Sheet: /CM5/ File: cm5.kicad_sch		
Title:		
Size: A4	Date:	Rev:
KiCad E.D.A. 10.0.3		Id: 2/4

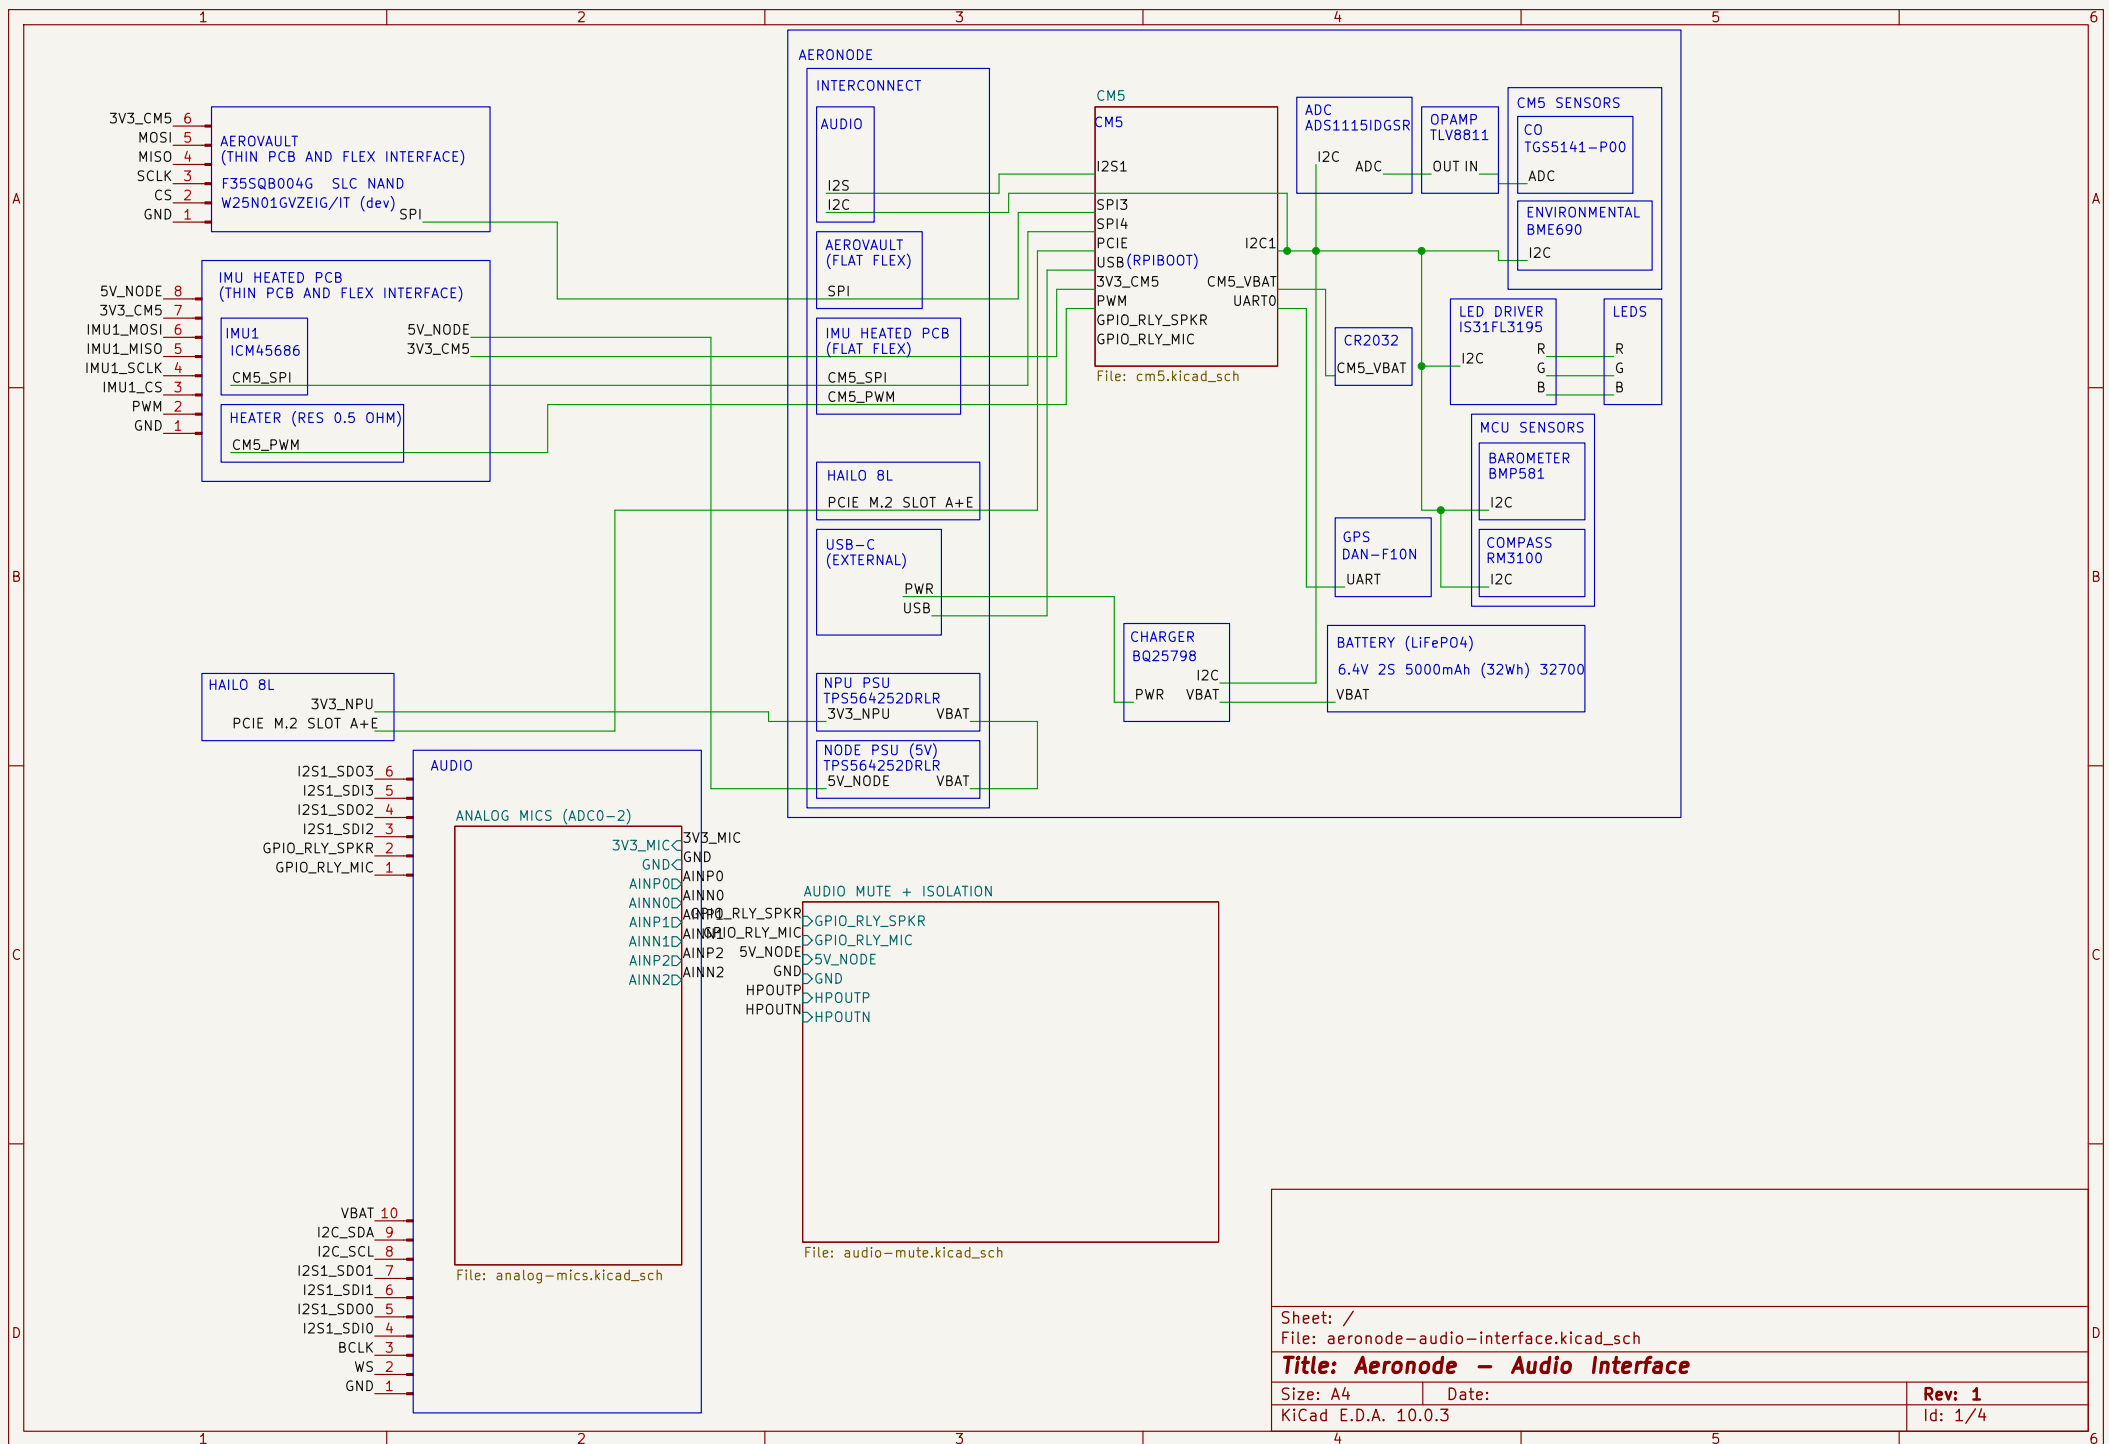
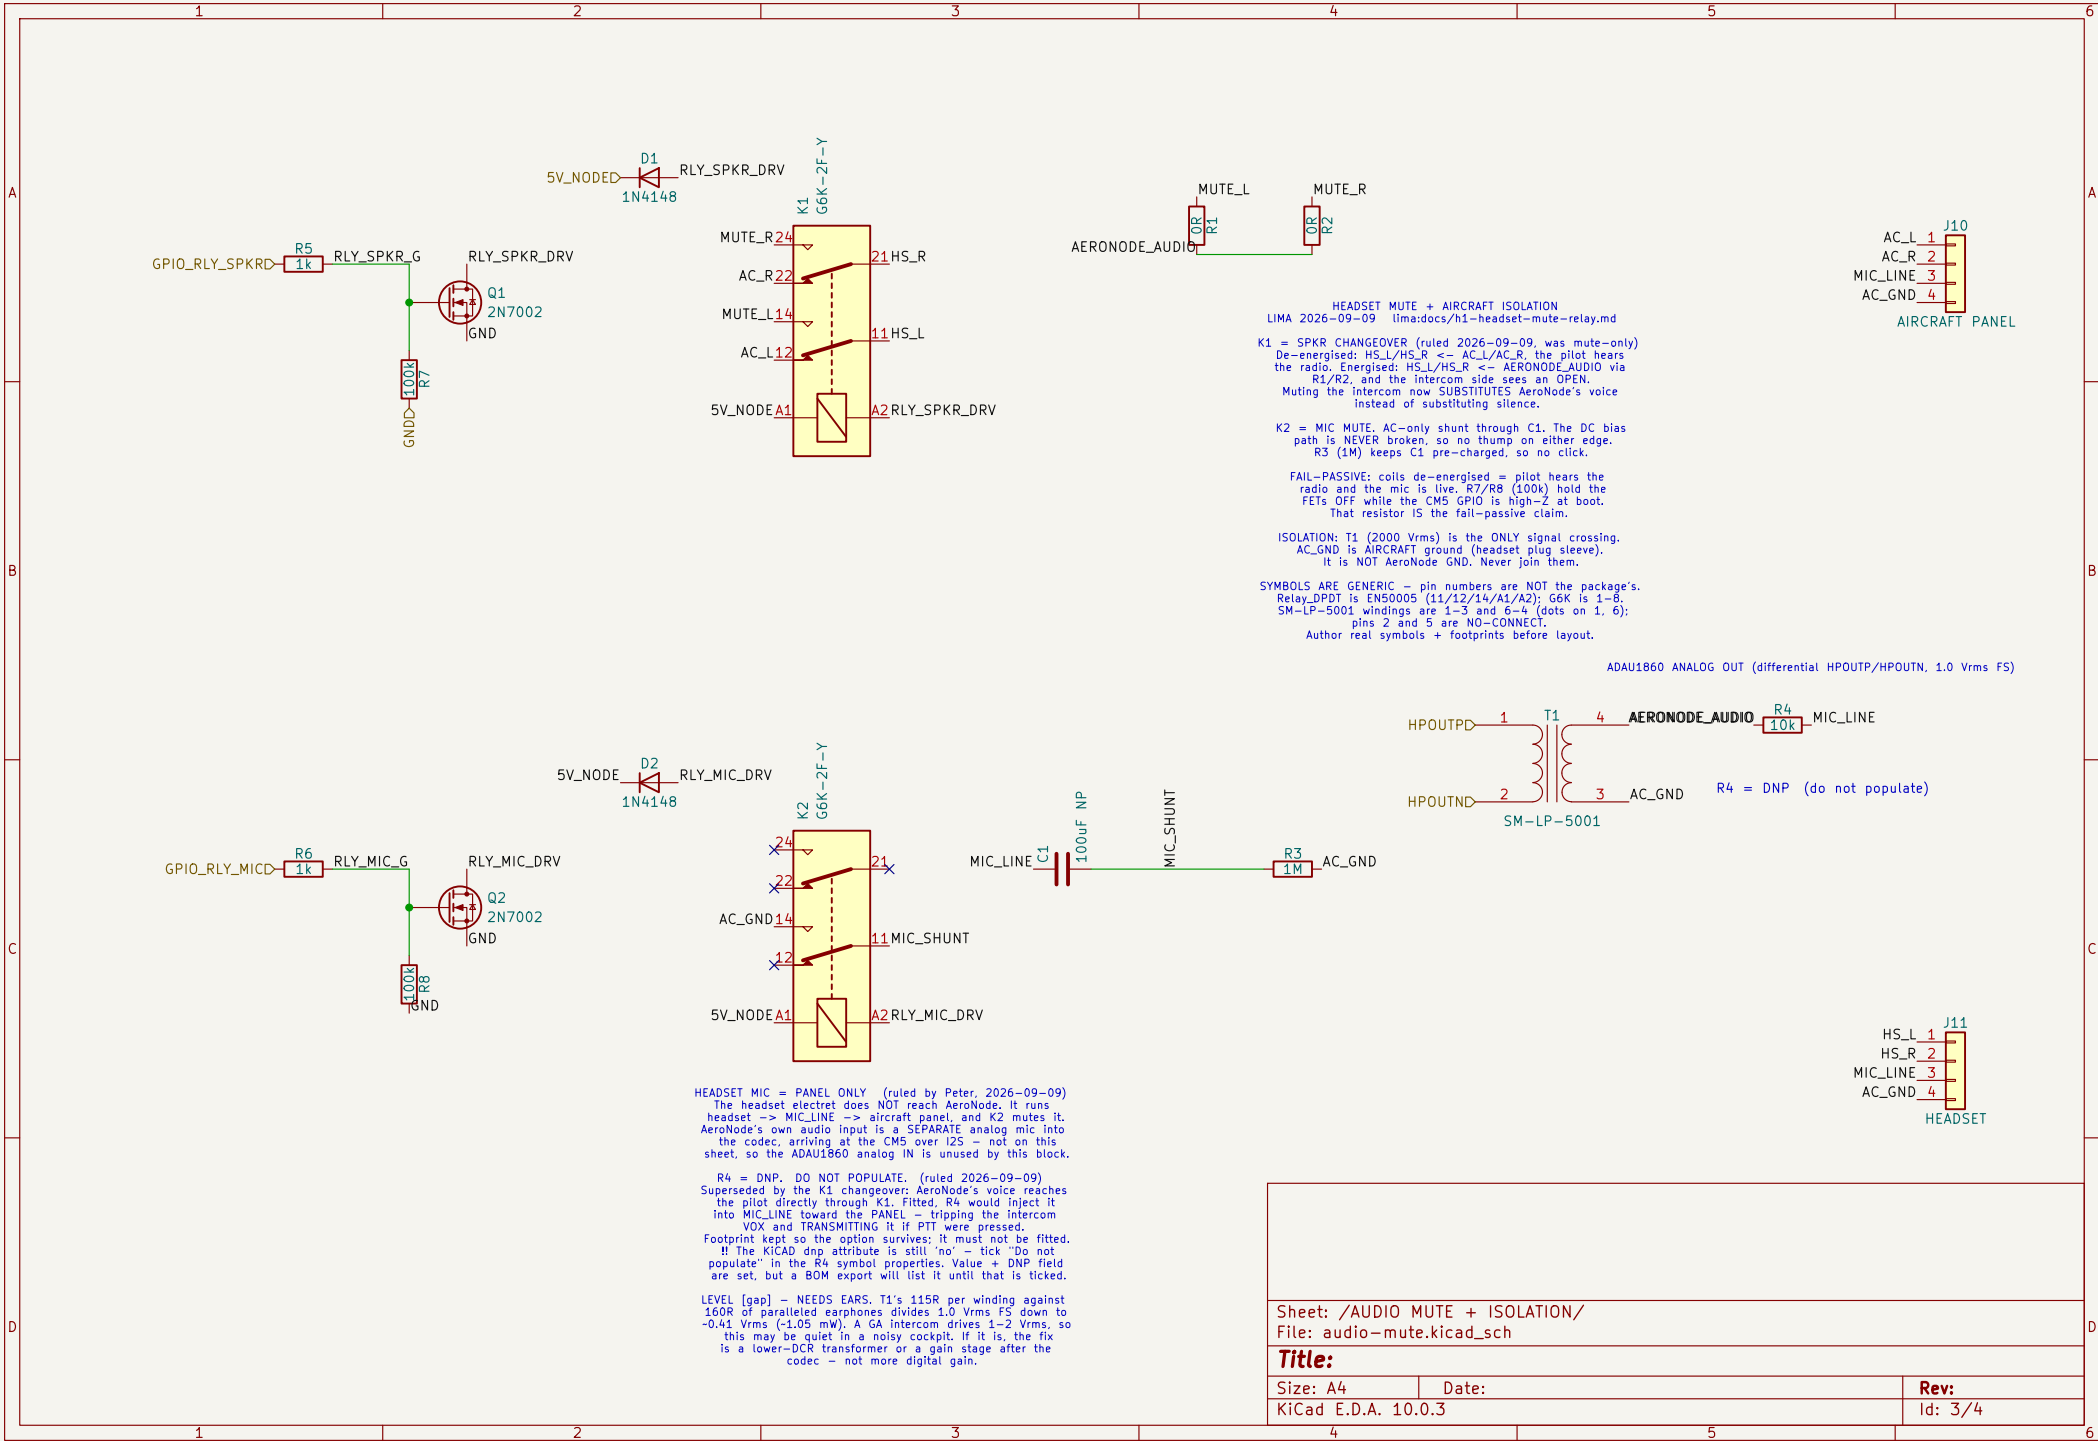
switching, or the ANC output needs its own always-on path. See section 19. T1 is NOT a blocker - I first read its 200 Hz-4 kHz spec band as a hard limit, but that is Bourns' 600R telecom condition. Into 160R from a low-Z drive the calculated corner is 3.4 Hz (-0.02 dB at 50 Hz). [gap] LF distortion unmeasured. LATENCY: at 48 kHz the ADC->DSP->DAC loop is -1 ms, too slow for feedforward above a few hundred Hz. Run ANC through FastDSP at a high rate - the datasheet characterises it at 768 kHz for exactly this.
